Please amend Figure 2E as shown in the enclosures. A clean copy of amended Figure 2E (labeled as a "Replacement Sheet") and a marked-up copy of Figure 2E (labeled as an "Annotated Sheet") showing the amendments in red are attached hereto.

REMARKS

The applicant has carefully considered the Office action dated May 4, 2005 and the references it cites. By way of this Response, claims 1, 3 and 4 have been amended and claim 7 has been cancelled without prejudice to its further prosecution. In view of the following, it is respectfully submitted that all pending claims are in condition for allowance and favorable reconsideration is respectfully requested.

FIG. 2E

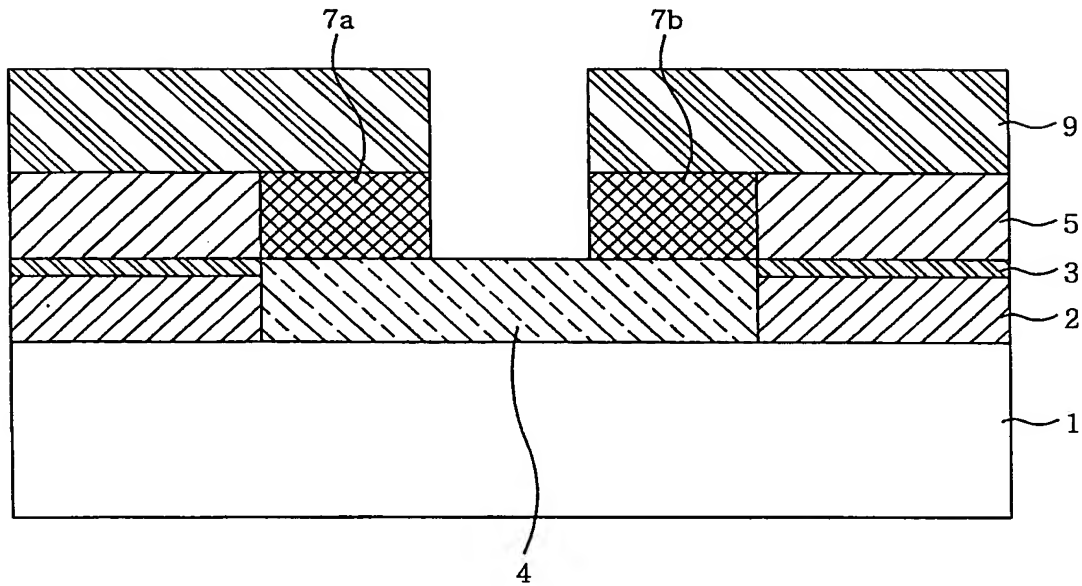
Turning first to the objections to the drawings, Fig. 2E has been amended to overcome the Examiner's objections. No new matter has been added. For example, the un-numbered layer erroneously included beneath the source/drain in FIG. 2E as filed, has been deleted for conformity with the prior figures and the written description. In addition, layer 3 from FIG. 2D has been added into FIG. 2E for conformity with FIGS. 2A-2D and the accompanying written description. Further, the shading of the source/drain regions has been corrected in FIG. 2E to match the shading in FIG. 2D.
